STATE OF HAWAII DEPARTMENT OF TRANSPORTATION HIGHWAYS DIVISION	
GABION WALL AND APRON DETAIL	
CASTLE HILLS ACCESS ROAD Drainage Improvements, Phase 2 FEDERAL-AID PROJECT NO. STP-0300(125)	
Scale: As Shown	Date: December 2011
SHEET No. C5.1 OF C5.4 SHEETS

ADD. 17

CASTLE HILLS ACCESS ROAD
Drainage Improvements, Phase 2
Federal-Aid Project No. STP-0300(125)

1
C4.1/C5.1**GABION CUTOFF WALL DETAIL**

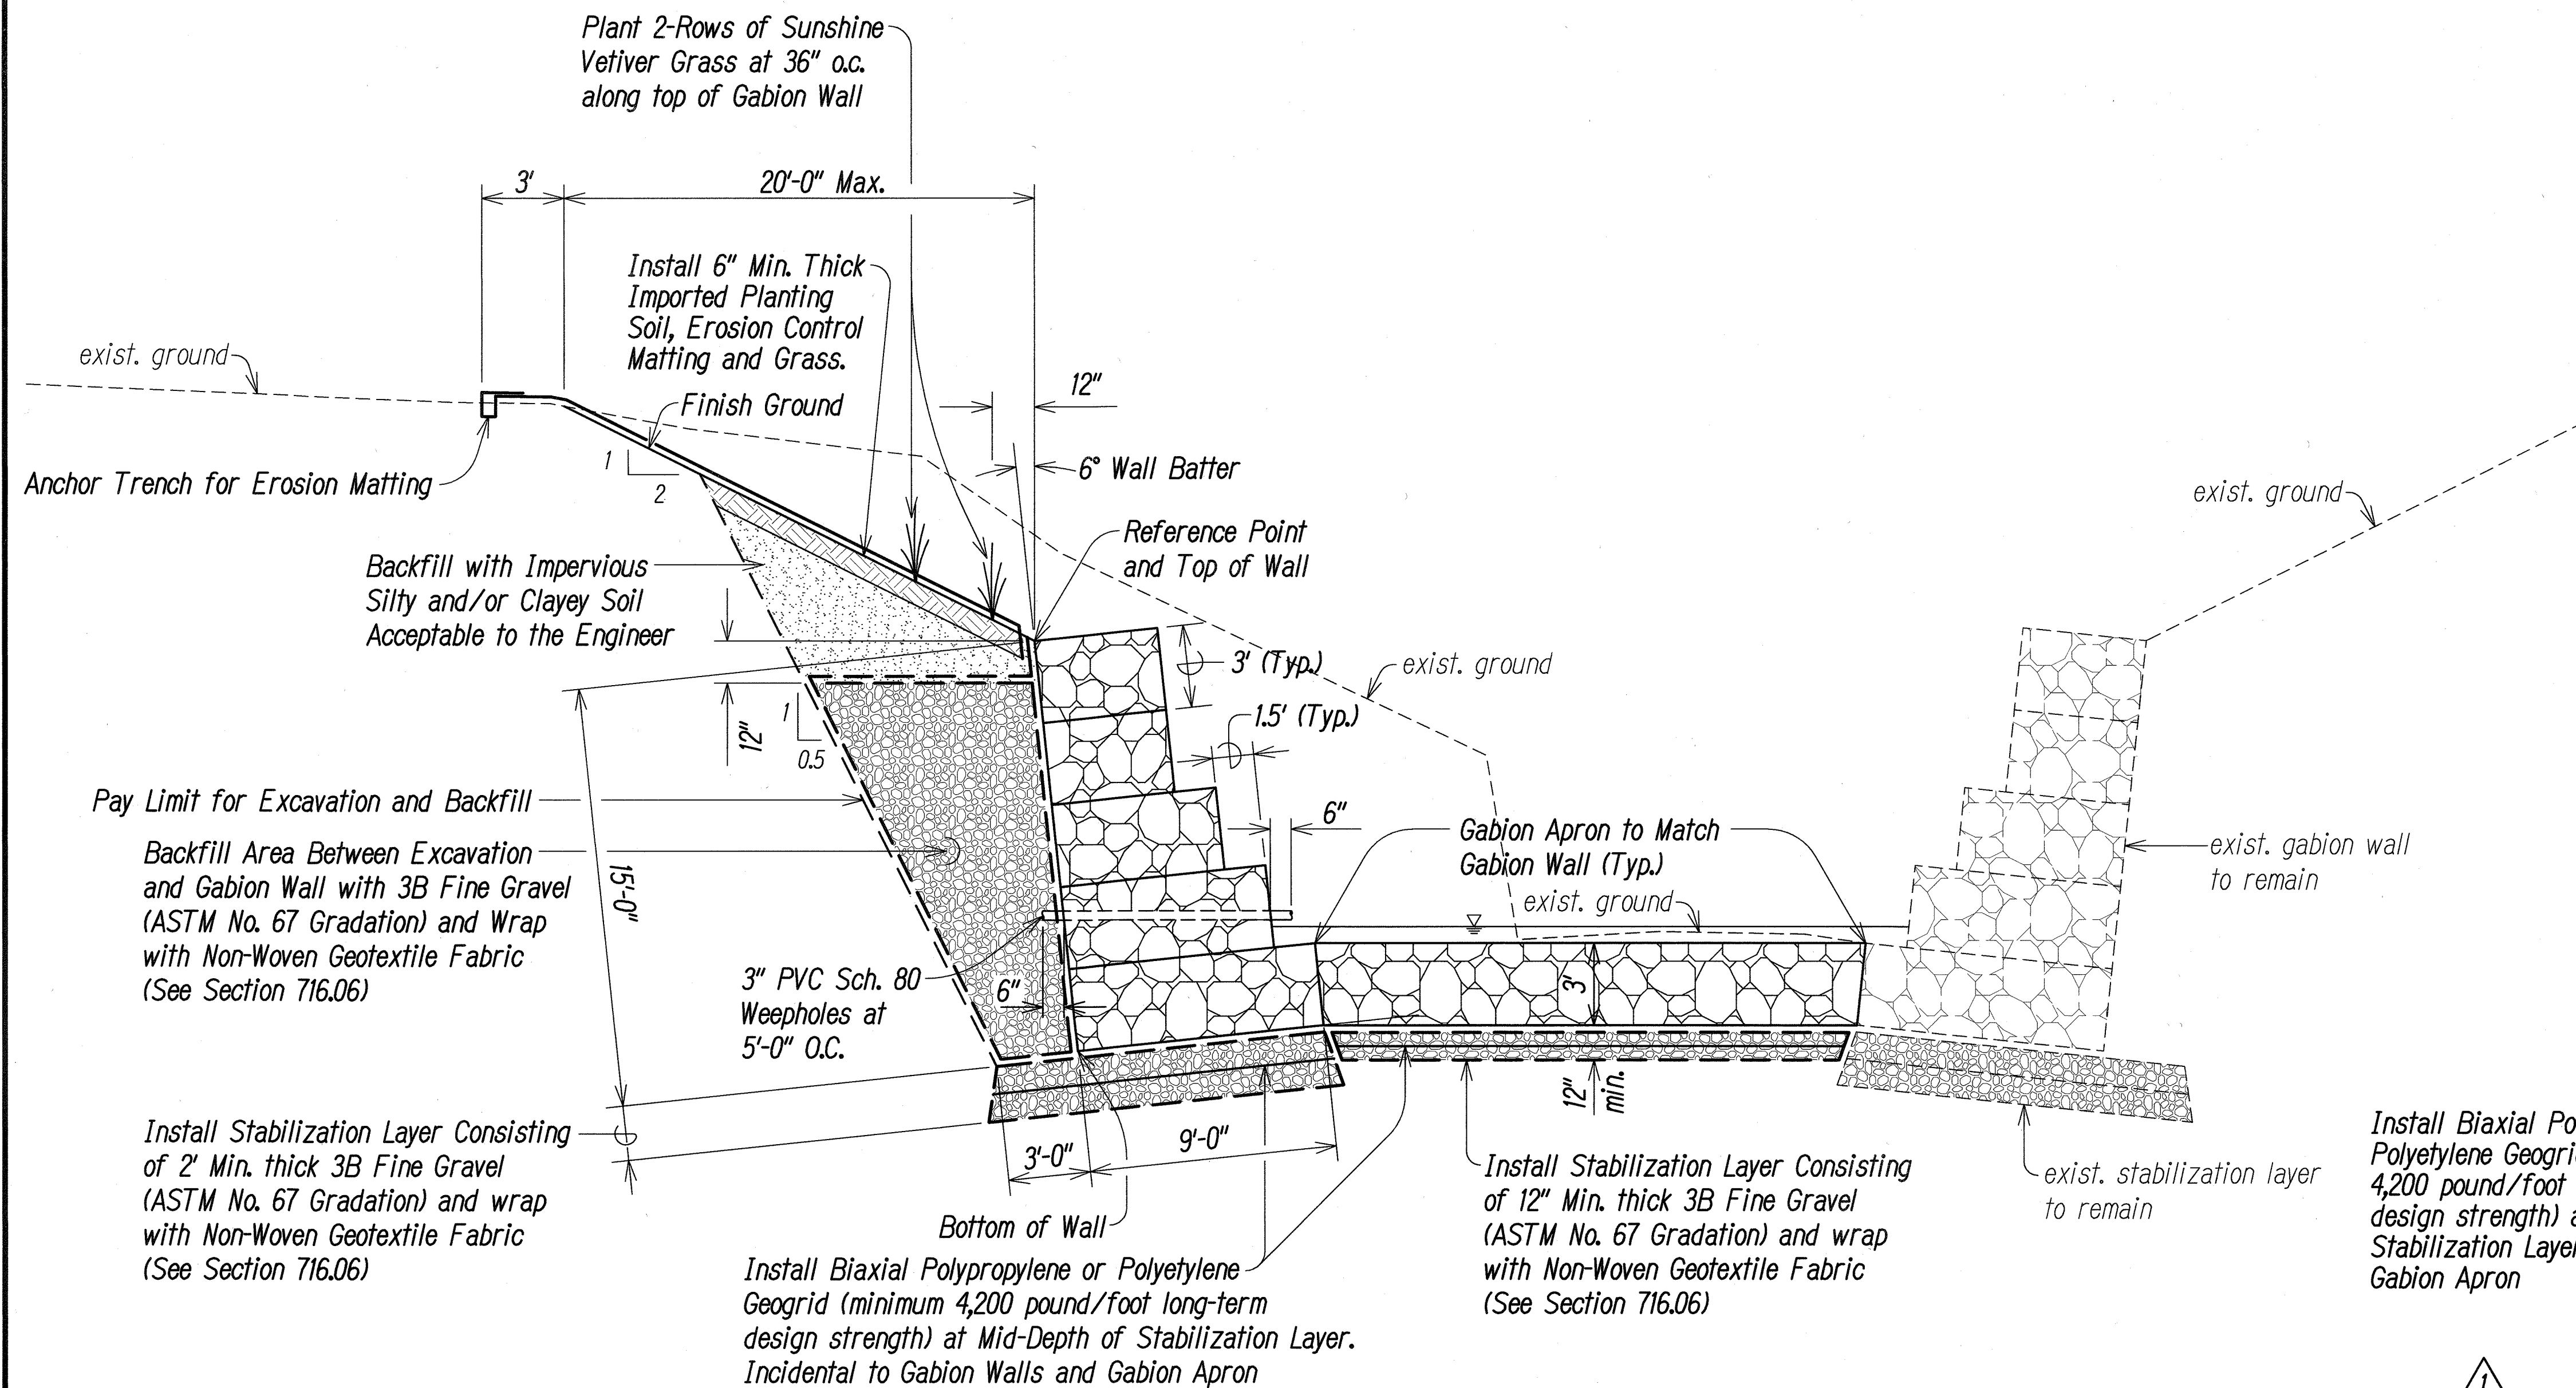
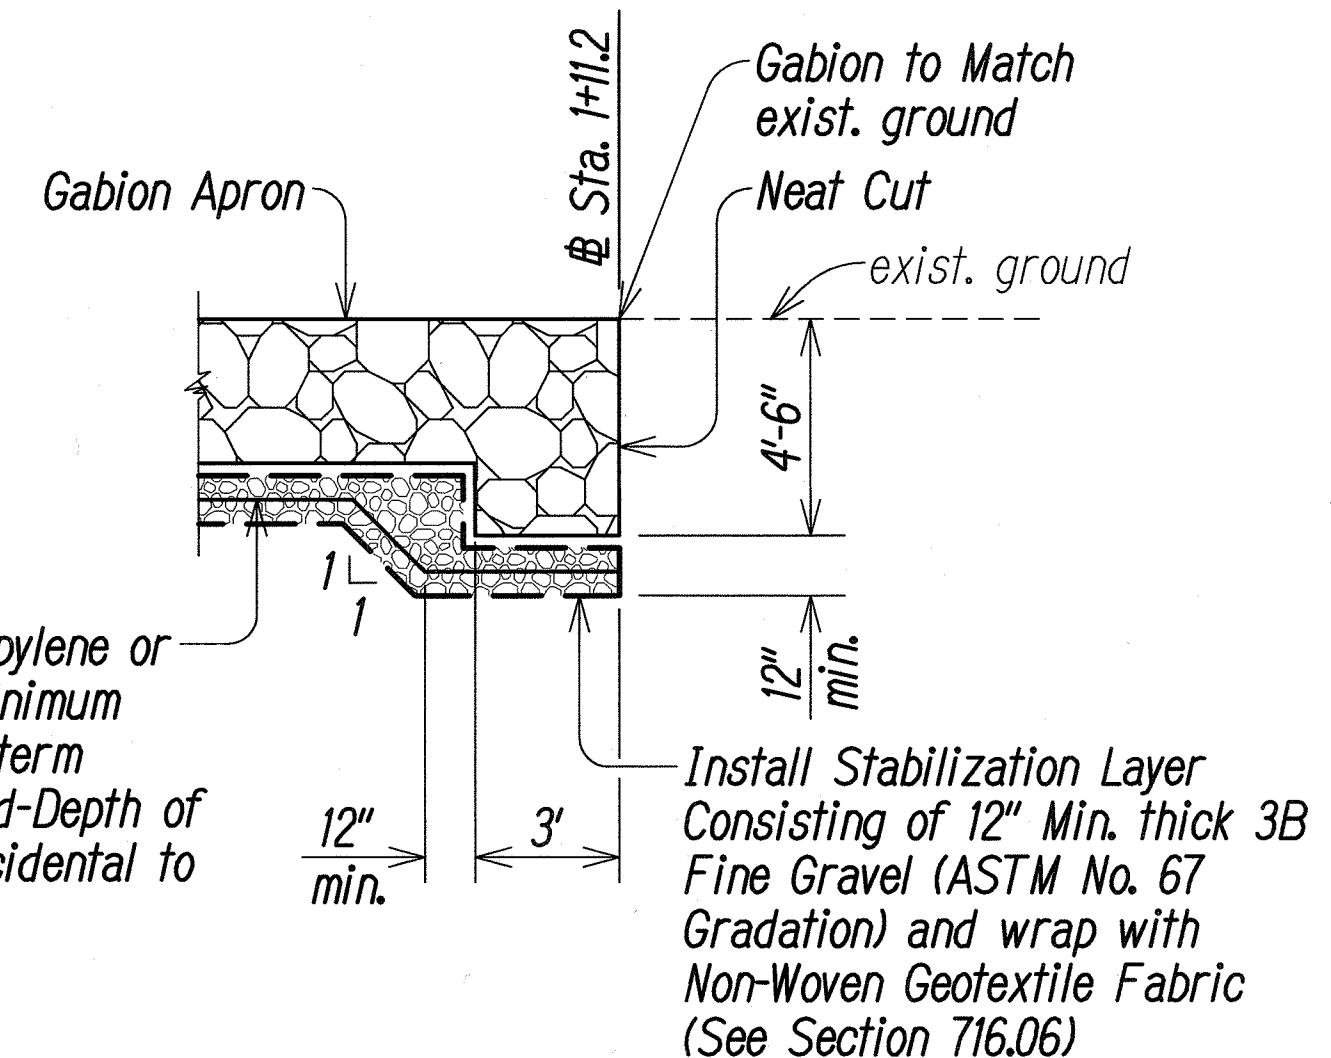
Deleted Stations. Added Gabion Cutoff Wall Detail.

Install Biaxial Polypropylene or Polyethylene Geogrid (minimum 4,200 pound/foot long-term design strength) at Mid-Depth of Stabilization Layer. Incidental to Gabion Apron

DROP STRUCTURE PLAN
Scale: 3/16" = 1'-0"

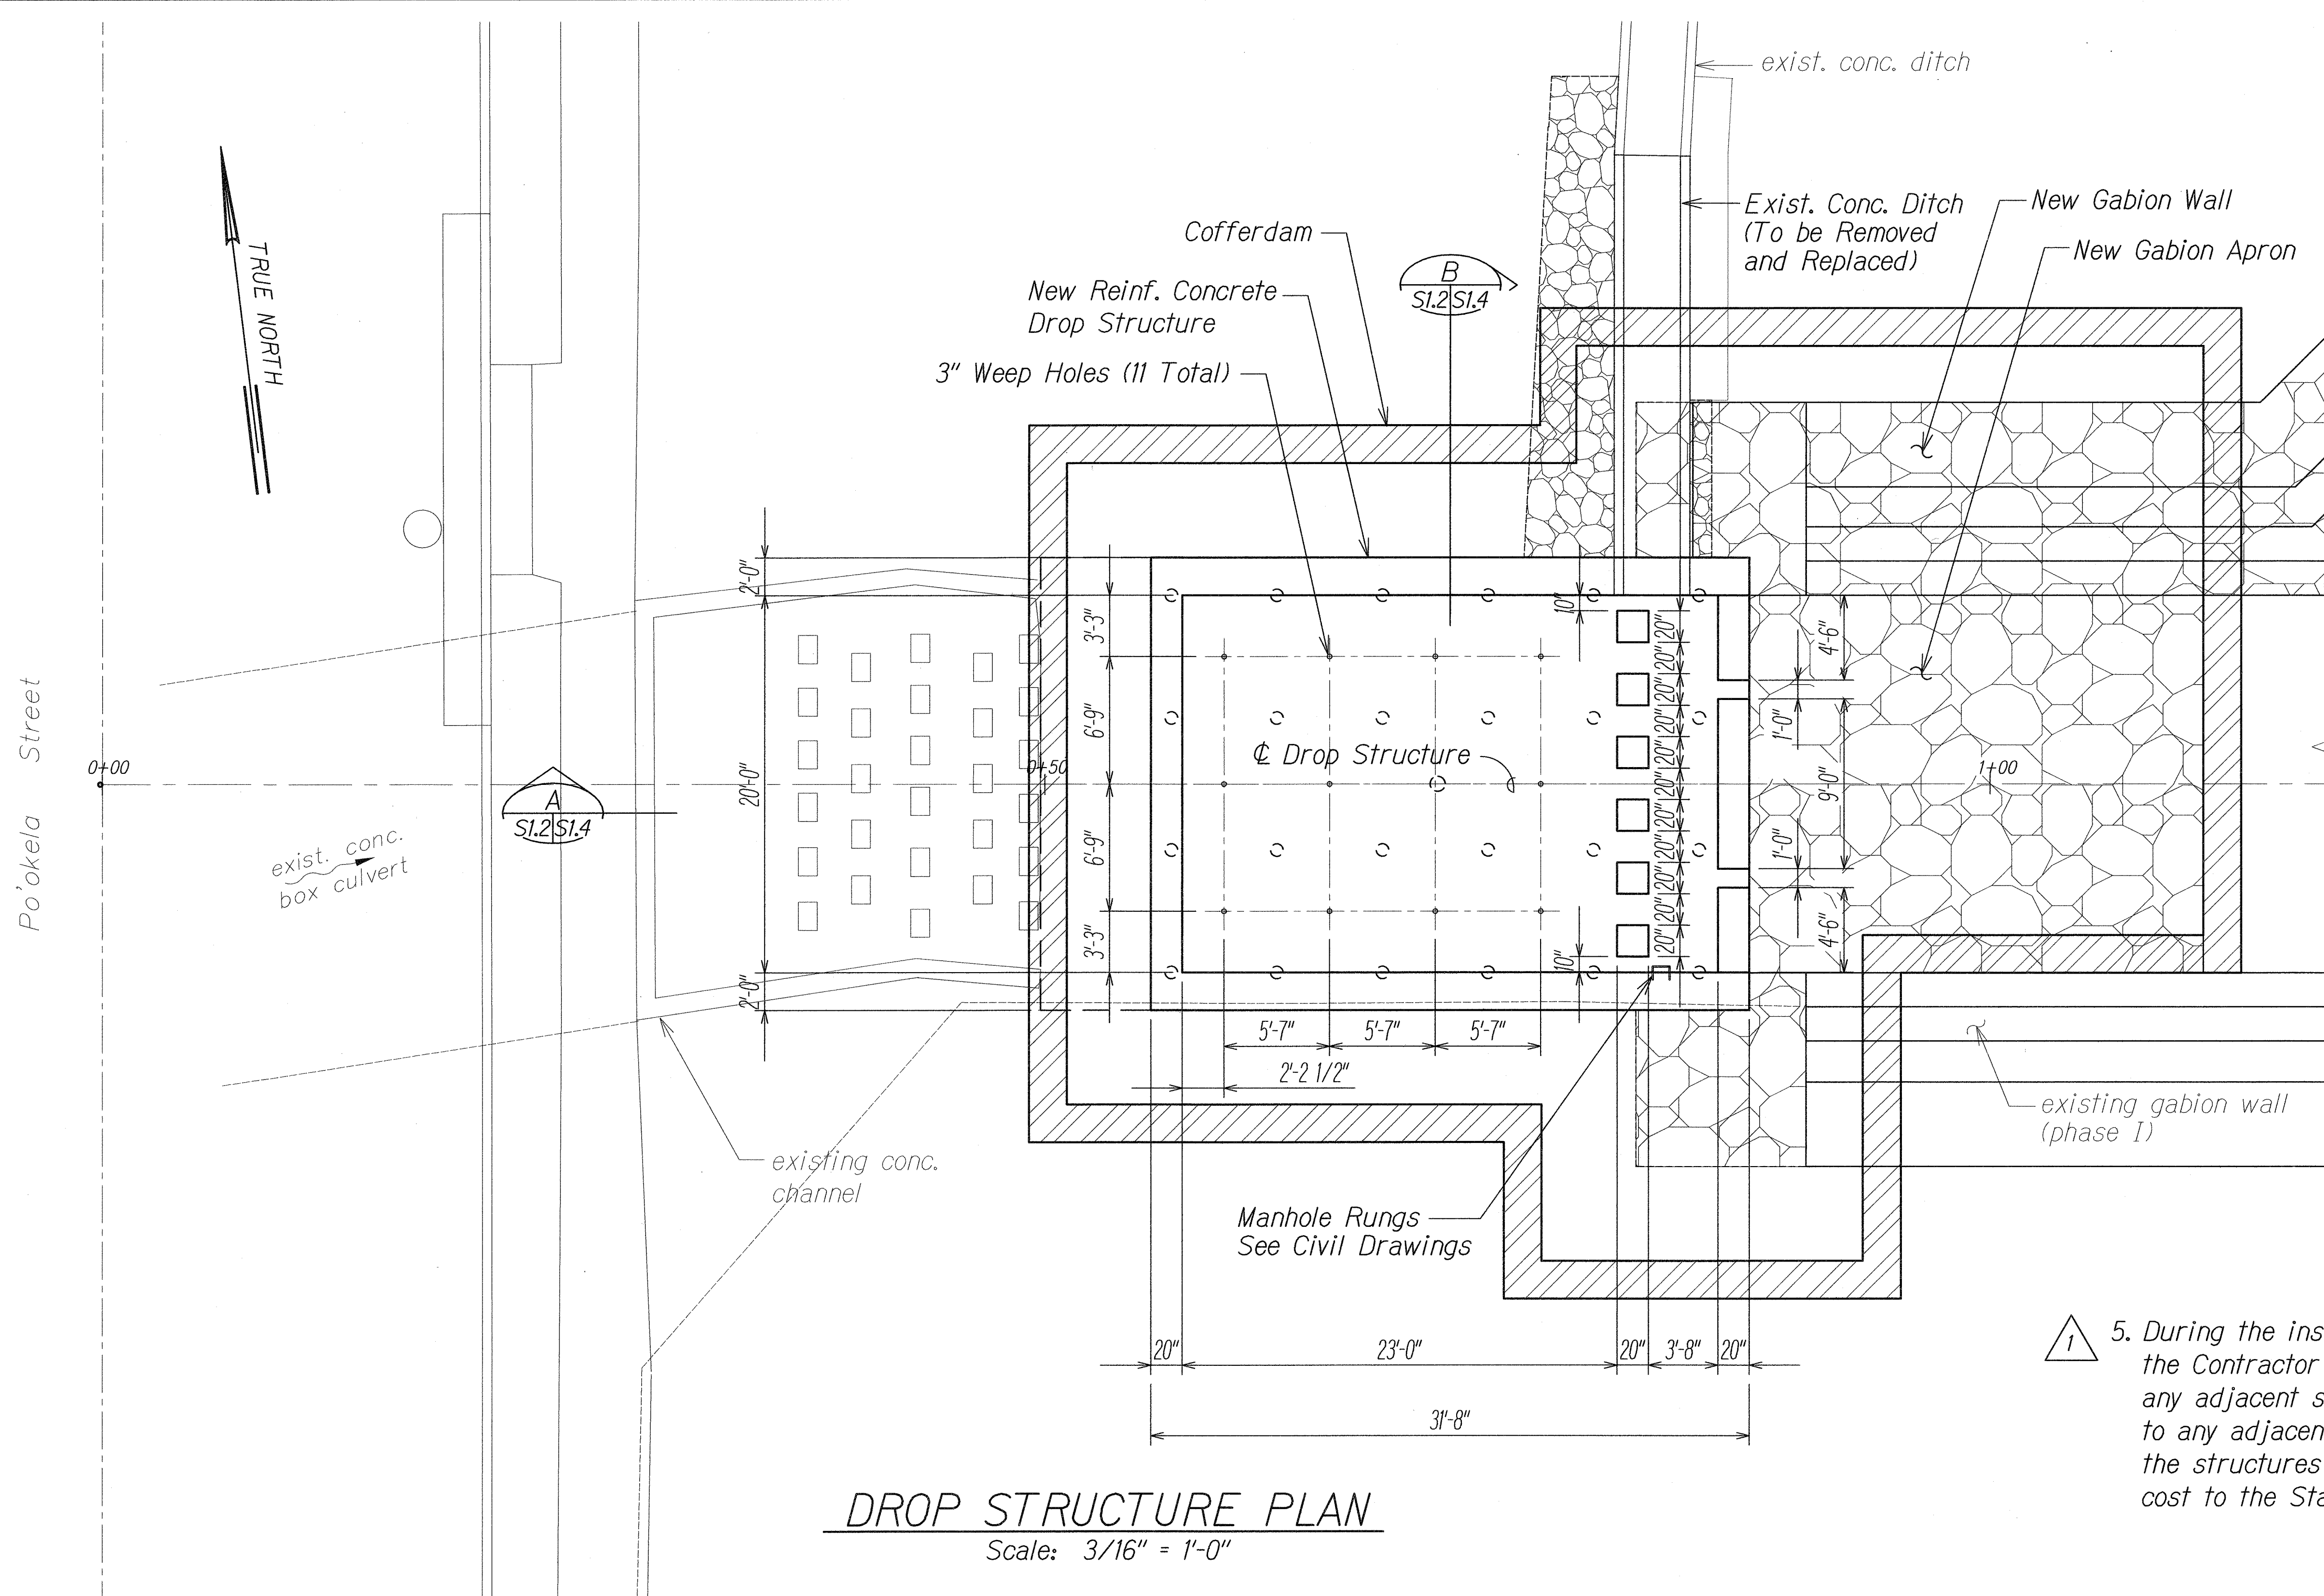
01/19/12 Added Note

- Notes:**
1. The Contractor shall install a cofferdam, with a minimum depth of 50 feet measured from the highest adjacent existing grade, to construct the drop structure. Except for the minimum depth, the exact location, details, and extent of the cofferdam shall be determined by the Contractor.

2. The adequacy and safety of the cofferdam and temporary excavation shall be the sole responsibility of the Contractor. See Foundation Notes on sheet no. S0.1.

3. The Contractor shall hire a civil engineer experienced in geotechnical engineering and a structural engineer, both licensed in State of Hawaii, to evaluate and provide design calculations and shop drawings for the cofferdam and temporary excavation. Plans and calculations shall be submitted to the Engineer for review and acceptance prior to performing any work on the cofferdam or excavation for the drop structure. The work for the evaluation, design, construction, and removal of the cofferdam and the temporary excavation will not be paid for separately but shall be considered incidental to Item No. 205.0400 Temporary Cofferdam for Concrete Drop Structure.

4. The construction sequence, access and method for the drop structure, including but not limited to the cofferdam and excavation, shall be submitted to the Engineer for review and acceptance prior to performing any work related to the drop structure. This work will not be paid for separately but shall be considered incidental to Item No. 205.0400 Temporary Cofferdam for Concrete Drop Structure.

5. During the installation and removal of the cofferdam, the Contractor shall ensure no damage is caused to any adjacent structures. If any damage does occur to any adjacent structures, the Contractor shall repair the structures to pre-construction conditions at no cost to the State.
